Subject: Arkansas Nuclear One - Unit 1
Docket No. 50-313
License No. DPR-51
Additional Information for 10CFR50 Appendix R
Exemption Request for Makeup Pump Rooms

Additional Information for ANO-1 Makeup Pump Rooms

Figure 2b ⇐ Compartment 5 ⇒

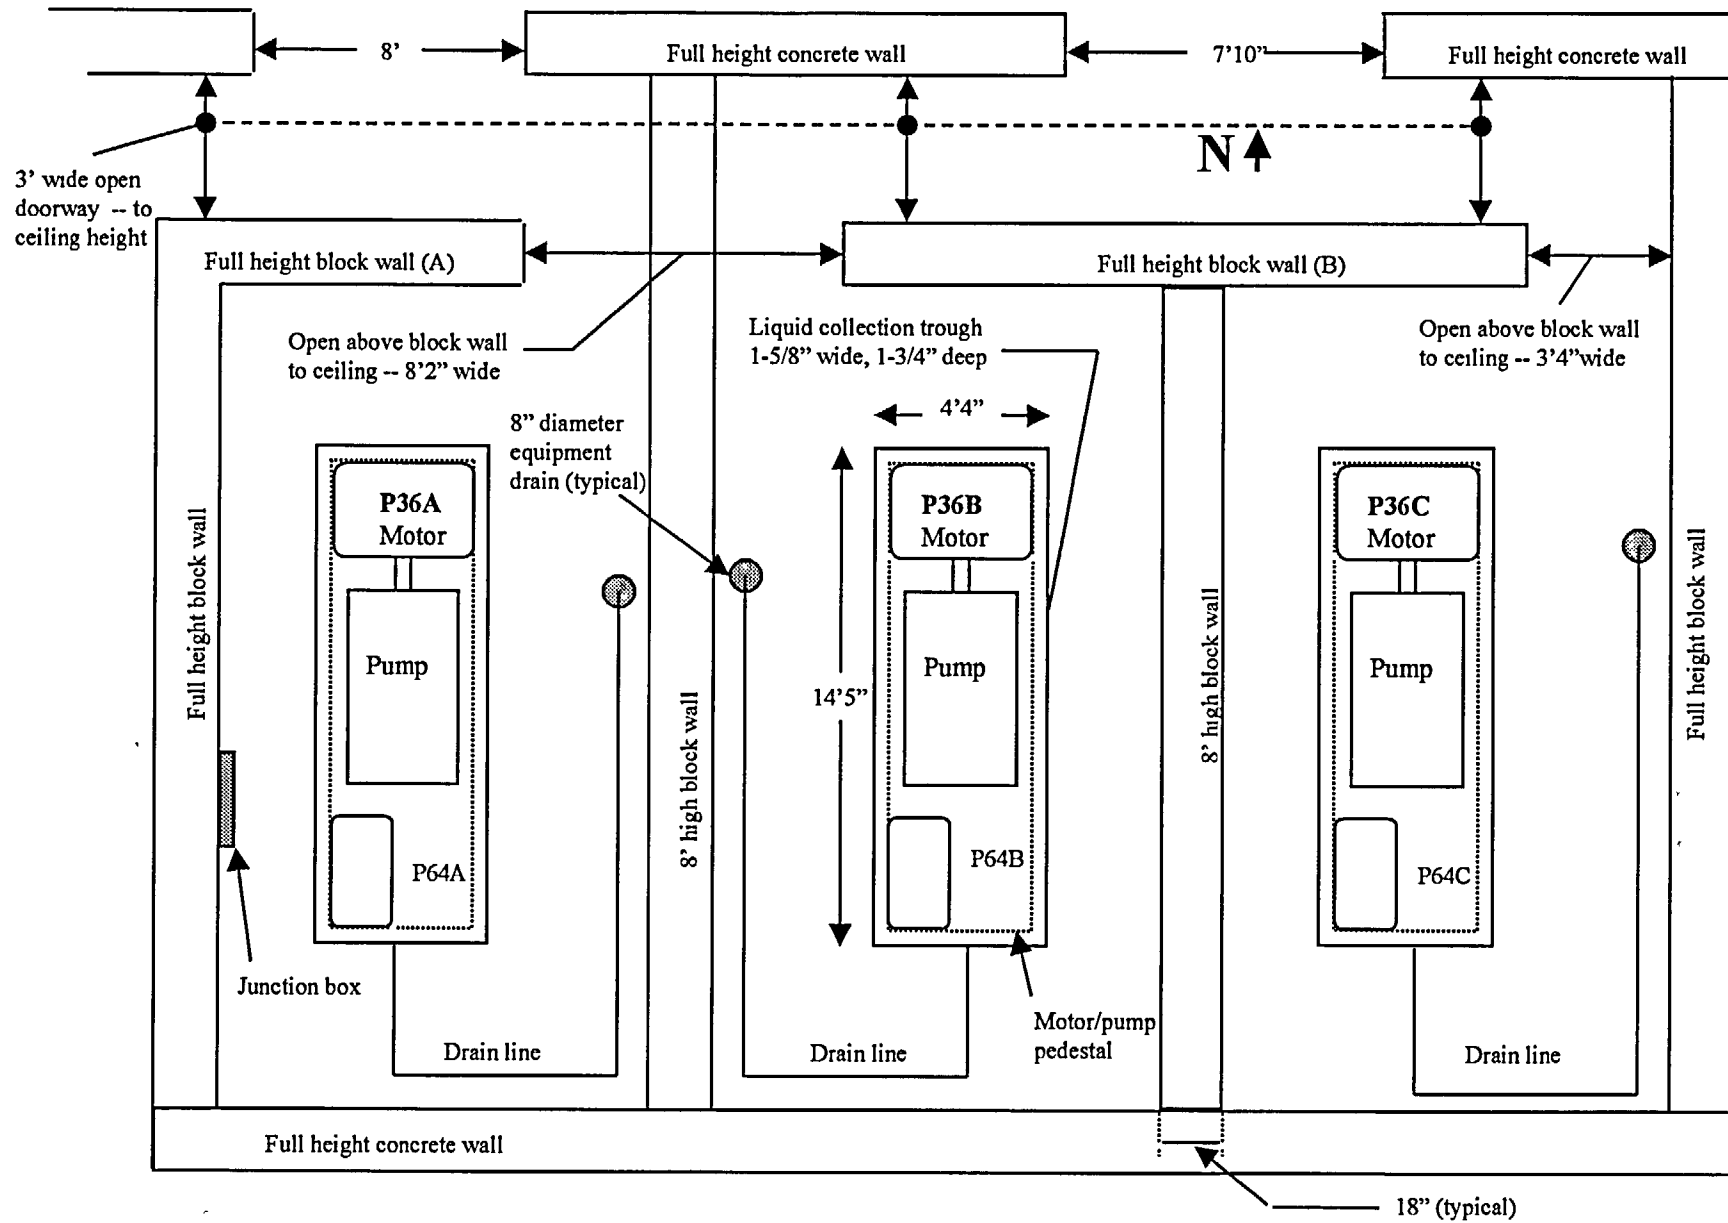
- The CFAST model is set up with four compartments. A five compartment configuration may be more appropriate. As modeled, the 'vent' to the fourth compartment (from compartments 1, 2, and 3) is specified as four feet wide with a soffit eight feet from ceiling. However, the 'doorway' into the tank room does not have a soffit (i.e., open to ceiling). The 'doorway' into the radwaste corridor does have a soffit, but each of the two openings is approximately eight feet wide.

- The architectural drawings that depict elevation 335' are A-107 sheet 1 and C-299 sheets 1, 6, 7, and 8. From these drawings, the tank room (suggested compartment #4) is located west of the makeup pump cubicles and is estimated from drawings to be 35 feet 10 inches x 24 feet 4 inches. The ceiling height is consistent with that of the makeup pump cubicles (i.e., 16 feet 3 inches). As noted on Figure 2b, the opening into the tank room is three feet wide and has no soffit (i.e., opening is flush with ceiling). The tank room ceiling is concrete except for the west end of the room, which is open to the elevation above. For conservatism and to simplify the model, the vent from the tank room to the elevation above should be neglected.

- Immediately north of the makeup pump cubicles is a small hallway. The volume of this hallway can be neglected, but will add to the conservatism of the model. The hallway connects the makeup pump cubicles to the tank room (via the above discussed opening) and to the larger corridor/open area (suggested compartment #5) that contains various radwaste equipment. The open area is large and can be conservatively estimated to be 95 feet x 95 feet. There are two openings into the open area (one north of P36A and the other north of P36B/P36C). These openings are approximately eight feet in width and have an eight foot soffit.
